SUBJECT: REVISION "B" TO TECHNICAL BULLETIN 212-88-105:

**TAILBOOM ASSEMBLIES, P/N 212-030-100-005 / -049 / -057
/ -063 / -069 / -097 / -103 / -115 / -121 / -133 / -147 / -159 / -177
/ -191 and -203, MODIFICATION FOR USE ON ALL MODEL
212 HELICOPTERS**

No. 212-88-105

REV B

Figure 1 (Sheet 1 of 2)
 2-way stop installation

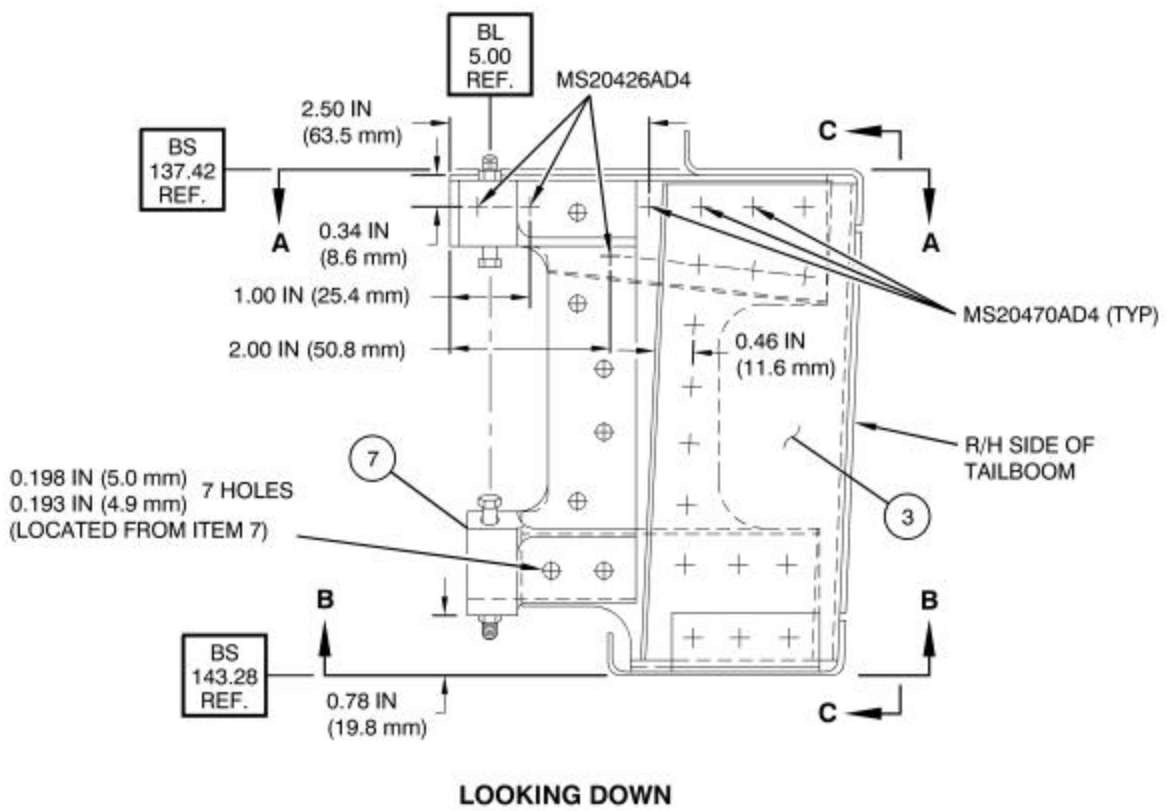
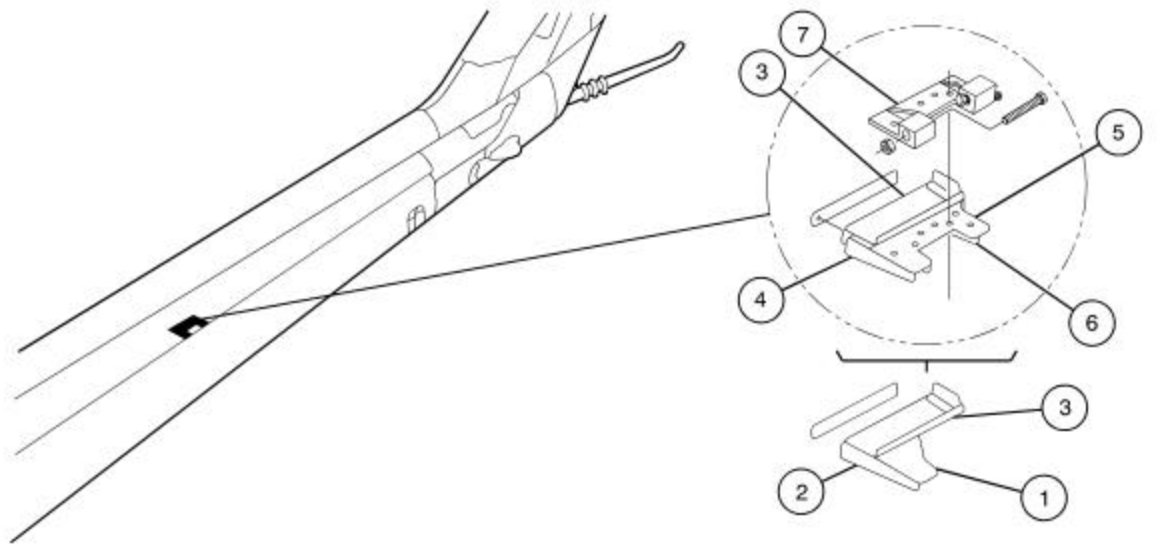
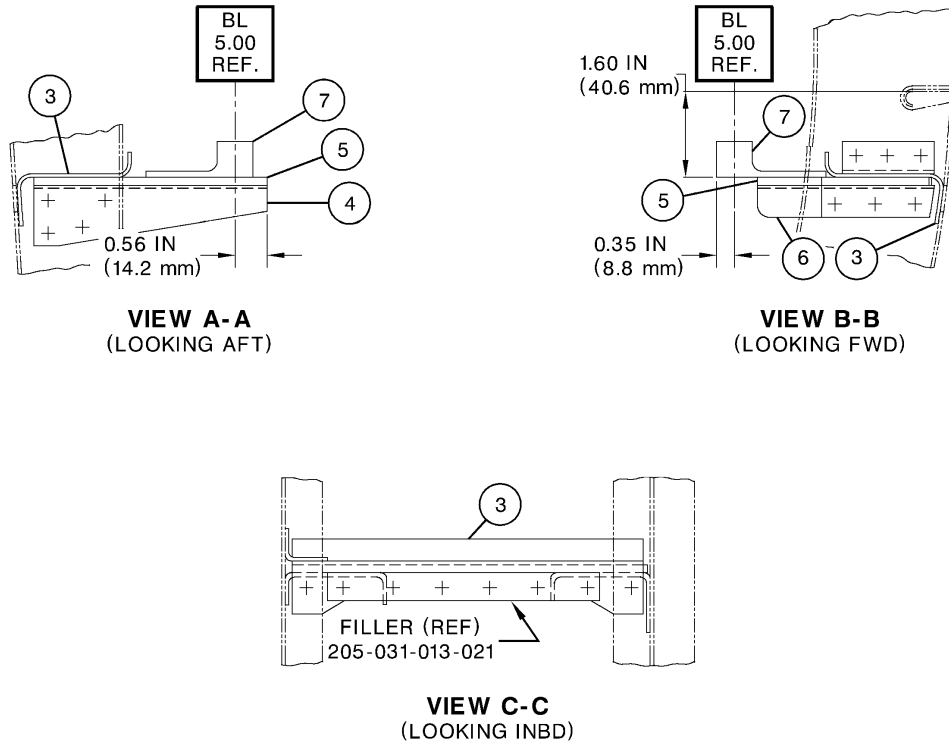
2. Replace elevator horn stop, if required per Table 1, using the following procedure and referring to Figure 1 & 2:
 - a. Move elevator horn away from work area (or remove horn assembly) to gain access to stop. Refer to maintenance manual, Chapter 67 for removal.
 - b. Remove existing stop (1), clip (2) and support (3).
 - c. Install new support (3), support (4), stop (5) and support (6), locate as shown on Figure 1. Maintain an edge distance of 2D for all brazier-head rivets and 2.5D for all countersunk rivets. Refer to BHT-MED-SRM-1 for rivet installation.

- d. Drill (Qty 7) holes in stop assy. (7) as per Figure 2.
 - e. Locate stop assy. (7), transfer holes to stop (5), support (6) and support (4).
 - f. Move elevator horn back to position (or reinstall). Refer to maintenance manual for reinstallation of elevator horn. Install stop assy. as per Figure 1 with screws P/N MS27039-1-11, washers P/N NAS1149D0332J and nuts P/N MS21042L3.

| REMOVE: | INSTALL: |
| 1. 205-031-013-019 | 3. 205-031-013-023 |
| 2. 205-031-013-015 | 4. 205-031-013-139 |
| 3. 205-031-013-023 | 5. 205-031-013-137 |
| | 6. 205-031-013-121 |
| | 7. 412-030-103-109 |

Figure 3
Installation of stiffener

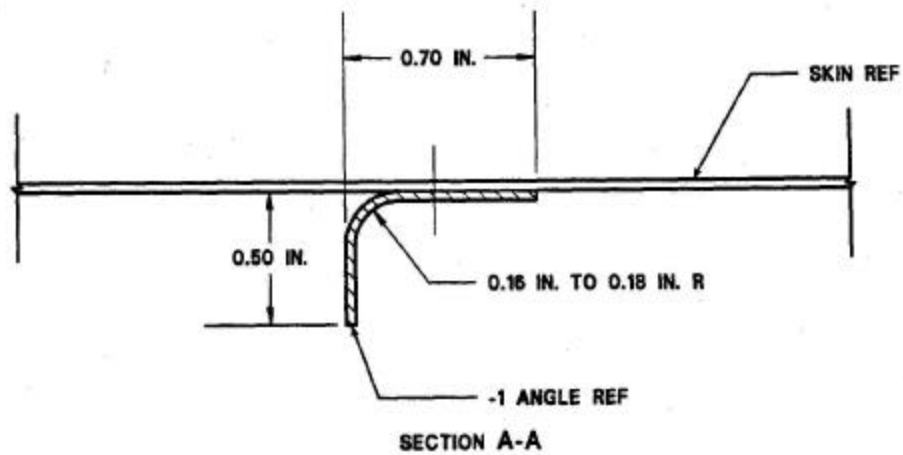
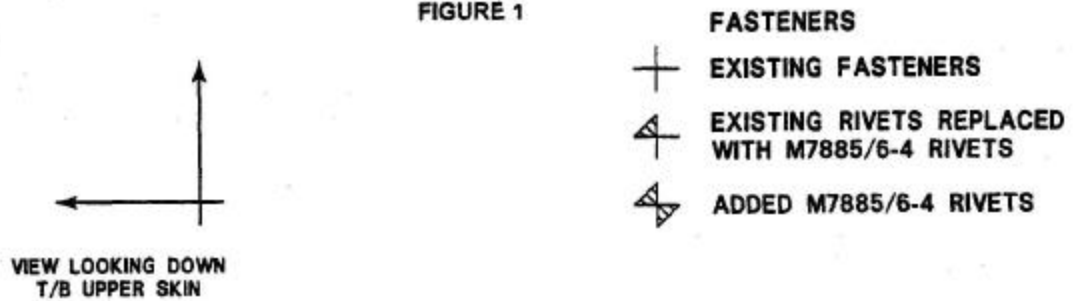
3. Install the top skin stiffener, if required per Table 1, using the following procedure and referring to Figure 3.
- a. Gain access to modification area by removing inspection panel in forward section of baggage compartment roof panel.

- b. Open forward drive shaft cover and remove tail rotor drive shaft section above modification area as per BHT-212-MM, Chapter 65.
 - c. Layout position of -1 stiffener angle to be installed on tailboom top skin as per dimensions noted on Figure 3.

- d. Remove (Qty 2) existing fasteners attaching L/H & R/H drive shaft cover angles to tailboom top skin.
 - e. Fabricate -1 stiffener angle from P/N 150-021-14C1-1 repair sheet dimensionally as per Figure 1 and section A-A. Alternate material 2024-T3 0.040" Al Alloy per QQ-A-250/4 may be used.

- f. Fabricate a template to transfer the two (2) existing fastener locations of step 3d with # 27 drill to template. Note the L/H - R/H orientation on template. Cleco template in position using the two existing fastener locations drilled in template. Lay out and drill six (6) # 40 pilot holes through template and tailboom top skin for the remaining holes, using pattern shown on Figure 1. Maintain proper edge distance and spacing.

- g. Use template to transfer the existing fasteners locations of step 3d with # 27 drill and the six (6) # 40 pilot holes into -1 stiffener angle. Note the L/H - R/H orientation and that the angle flange of the -1 stiffener angle is to be installed forward as per Figure 3. Maintain proper edge distance and spacing.

- k. Locate -1 stiffener angle in position on underside of tailboom top skin using lockwire. This is done by routing two (2) strands of lockwire down through two separate holes previously drilled in the tailboom top skin and out through the access panel hole. Attach the lock-wire to the same hole locations in the -1 stiffener angle in a manner that when the -1 stiffener angle is pulled up into position the wire can be released or pushed back through access panel opening, to facilitate removal of the lock-wire. Note that the -1 stiffener angle flange is to be installed forward as per Figure 1. Use clecos to hold in position. Secure using fasteners specified in Figure 3 with wet sealant P/N MILS81733TY II-2 4OZ
